# Access Compliance Report

## Public Rights-of-Way

### (Curb Ramps)

Intersection ID: 13538	Main Street: SOUTHWOOD_AV	Cross Street: W_PARK_AV	Location: S
ADA ID: 8AA443D5767C	Ramp Type: BlendTrans1	Initial Pass/Fail: Fail	Overall Compliance: No
Severity Score: 1.25			
Codes/Mitigation Info/Possible Solution		Field Measurements/Component Compliance

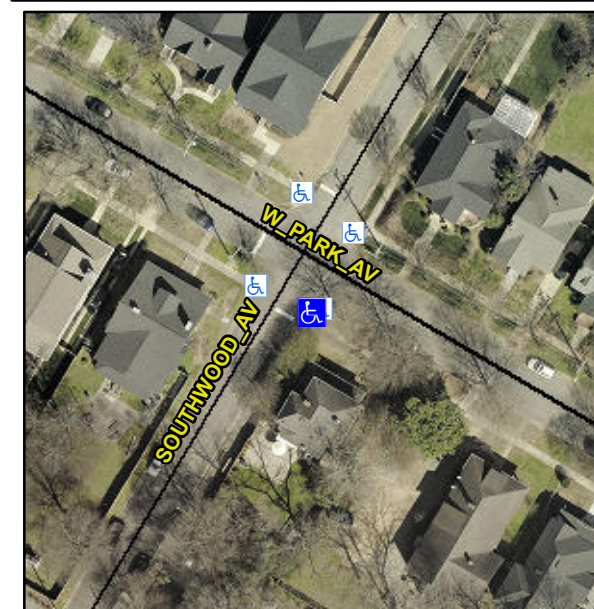
**Not Found, R304.5.3**

Compliance	Description	Data	Compliance	Description	Data
N/A	Ramp Length (in)	63.0	Yes	BlendTrans Slope (%)	0.2
Yes	Ramp Width (in)	60.0	No	BlendTrans XSlope (%)	3.2
N/A	Flare Type LT	N/A	N/A	Flare Type RT	N/A
N/A	Flare Slope LT (%)	N/A	N/A	Flare Slope RT (%)	N/A
N/A	Flare Traversable LT?	N/A	N/A	Flare Traversable RT?	N/A
N/A	Landing Length (in)	N/A	N/A	DWS Provided?	N/A
N/A	Landing Width (in)	N/A	N/A	DWS Contrast?	N/A
N/A	Landing Slope (%)	N/A	N/A	DWS Length (in)	N/A
N/A	Landing X Slope (%)	N/A	N/A	DWS Full Width?	N/A
N/A	Landing Curb? (Y/N)	N/A	N/A	DWS Offset (in)	N/A
N/A	Shared Landing?	N/A			
N/A	Gutter Ponding?	N/A	N/A	Gutter Slope (%)	N/A
N/A	Gutter Lip Ht (in)	N/A	N/A	Gutter X Slope (%)	N/A
N/A	Painted X Walk1?	No	N/A	Painted X Walk2?	N/A
	X Walk 1 Direction	To NW		X Walk 2 Direction	N/A
	X Walk 1 Width (in)	N/A		X Walk 2 Width (in)	N/A
	X Walk 1 Slope (%)	1.4		X Walk 2 Slope (%)	N/A
	X Walk 1 X Slope (%)	2.2		X Walk 2 X Slope (%)	N/A

N/A	Ramp inside XWalk1?	N/A	N/A	Ramp inside XWalk2?	N/A
	Road Slope (%)	2.2		Clear Space?	N/A
	Road X Slope (%)	1.4	N/A	Clear Space to XWalk (in)	N/A
N/A	Any Obstructions?	N/A	N/A	Storm Grate/Utility Hazard?	N/A
	Obstruction Type			Storm Grate/Utility Type	
		N/A			N/A
			Yes	Surface Condition? (G/P)	Good
			No	Curb Slope (%)	26.0

**Remove & Replace Curb Ramp With Two New Directional Ramps or Equivalent.**
